REMARKS/ARGUMENTS

Amendments to the Drawings:

Appl. No. 10/767,751 Preliminary Amdt dated 03/04/2005

Fig 14A

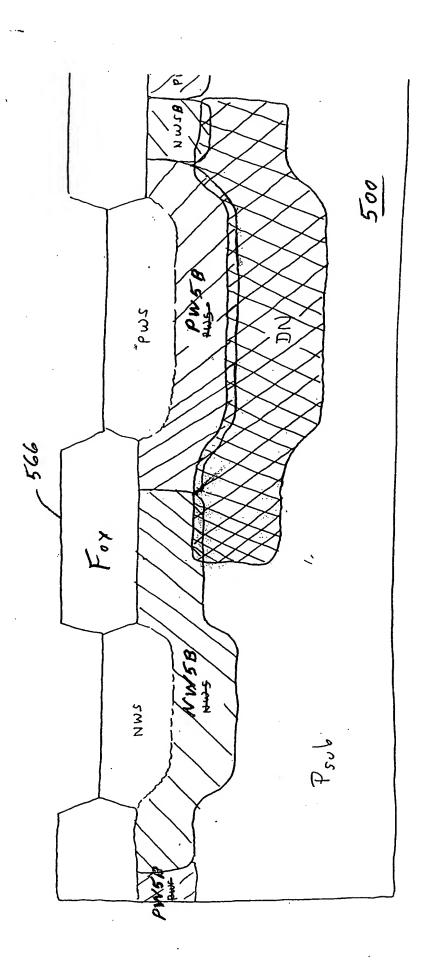
In Figs. 14A-14E, 14H-14P, 15A, 16A, 16B, 16D and 16F, in a number of instances the reference numeral PW5 has been changed to PW5B, the reference numeral NW5 has been changed to NW5B, the reference numeral PW12 has been changed to PW12B, and the reference numeral NW12 has been changed to NW12B, as shown on the enclosed Annotated Sheets. These changes are clearly supported, for example, at page 36, lines 14-17, of the substitute specification filed February 18, 2004, where it is indicated that the suffix "B" is used to denote an implanted layer of dopant as opposed to a "well" of dopant. In any event, these changes are merely changes in labeling and as such do not constitute new matter.

Fig. 188

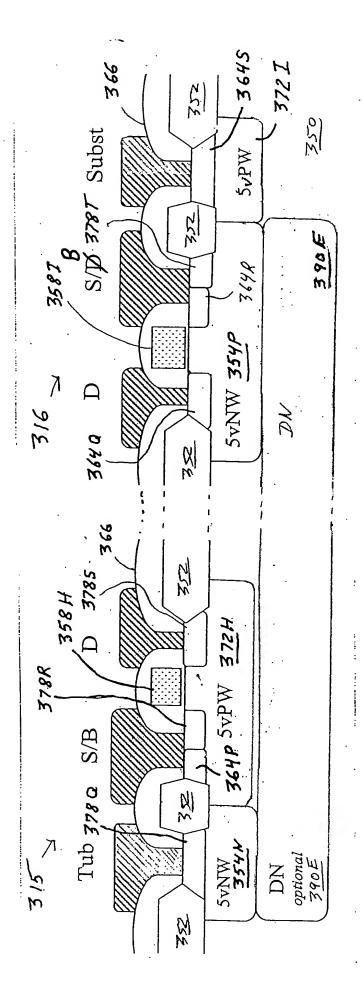
To make the drawings more legible, Figs. 18A and 18B have each been split into four drawings, designated Figs. 18A-1 to 18A-4 and Figs. 18B-1 to 18B-4, respectively. The subject matter in Figs. 18A-1 to 18A-4 and 18B-1 to 18B-3 is unchanged. In Fig. 18B-4, the reference numeral 354M has been replaced by the numeral 354L. The numeral 354M was an error. There is no such reference numeral in the application as filed.

F19 18C

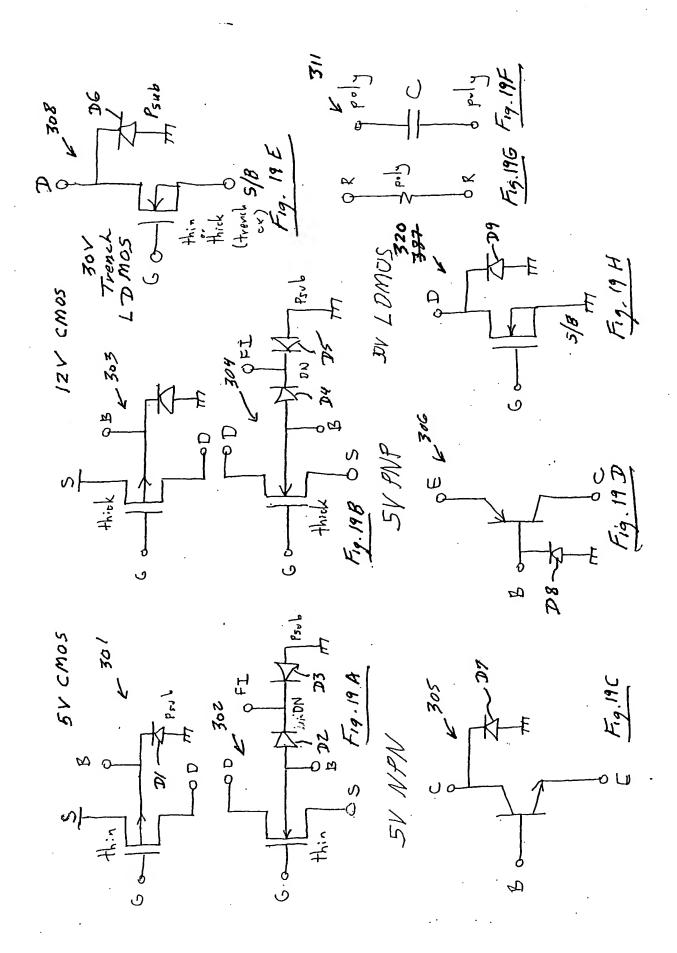
In Fig. 18C, the reference numeral 364P, which is referred to at page 66, line 4, of the substitute specification, has been added, and the designation of the source-body contact has been corrected from "S/D" to "S/B".

Interlayer Dieletric Fig 33D

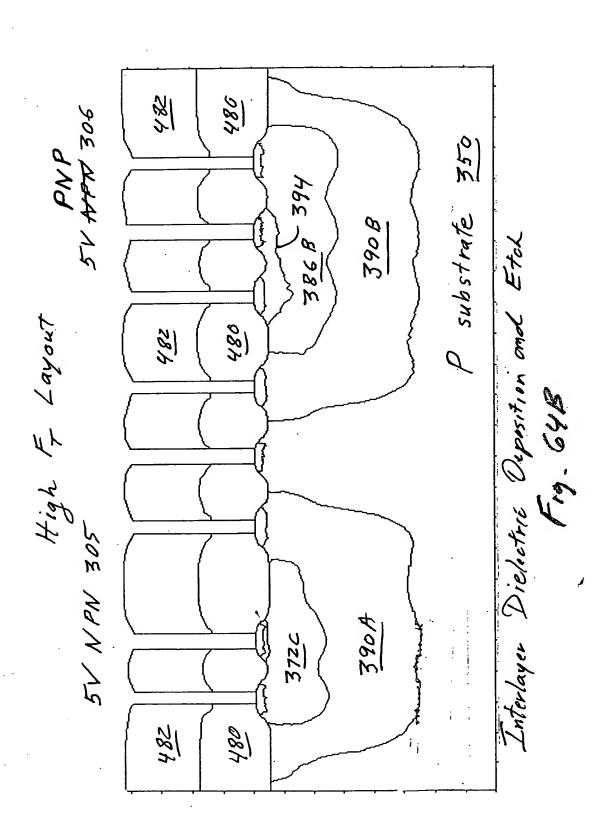
In Fig. 33D, the reference numeral 486 has been deleted. It is not referenced in the specification.

Fig. 18 H

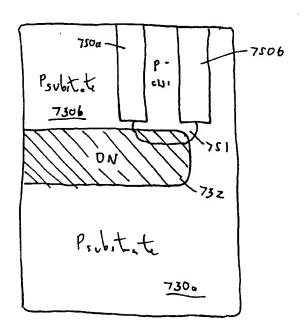
In Fig. 18H, the reference numeral applicable to the well NW5 has been changed from 354R to 354S to eliminate the conflict with the similarly numbered element in Fig.

18G; and the reference numeral applicable to the deep N layer has been changed from 390G to 390H to eliminate the conflict with the similarly numbered element in Fig. 35A.
